MISSISSIPPI RIVER 9-FOOT CHANNEL PROJECT

DEFINITE PROJECT REPORT/ ENVIRONMENTAL ASSESSMENT

POOL 3/UPPER POOL 4

CHANNEL MANAGEMENT STUDY

Figure 1

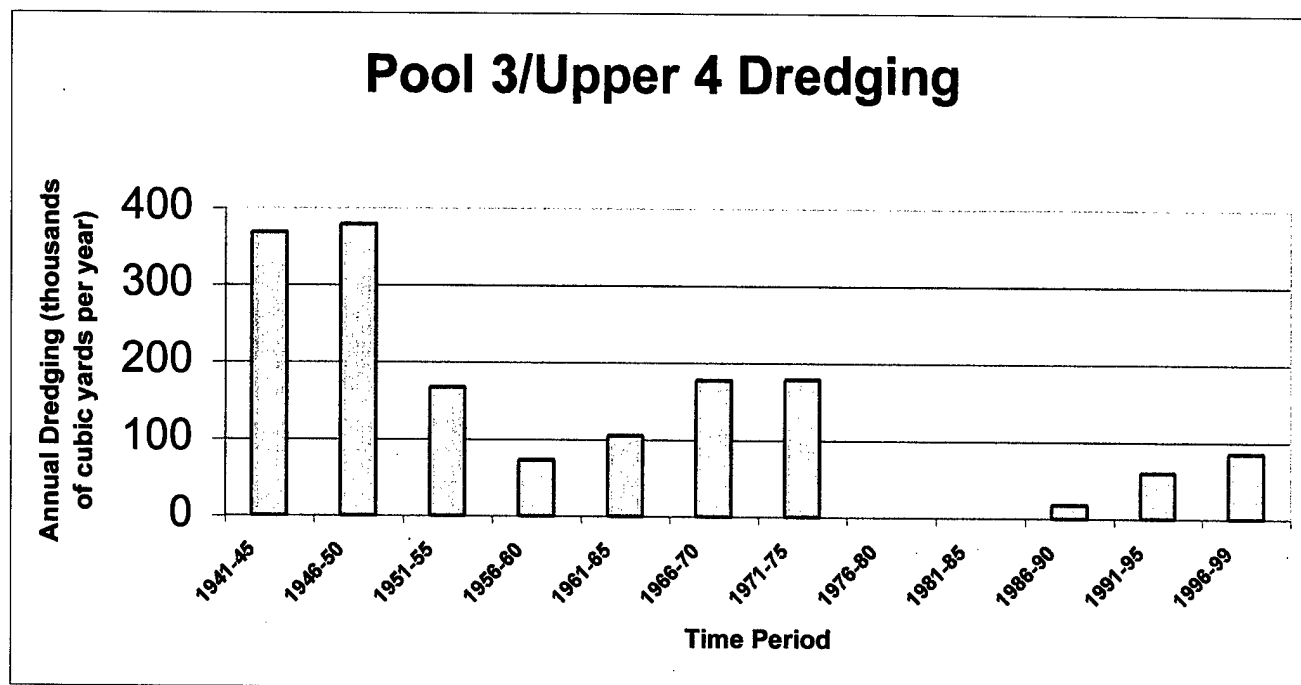
12 | Figure 1, page 5-4, should have an asterisk by the years 1996-98 with an explanation of the higher dredging quantities during those years. The quantities of material dredged in 1998 were higher than normal because the contractor cleaned out the channel during the process of unloading Corps Island. I believe 120,000 cubic yards was taken out of the channel in 1998 and even though minimal depth dredging was the normal during the last several years, this amount was in excess of what would typically be dredged to maintain the nine-foot channel.
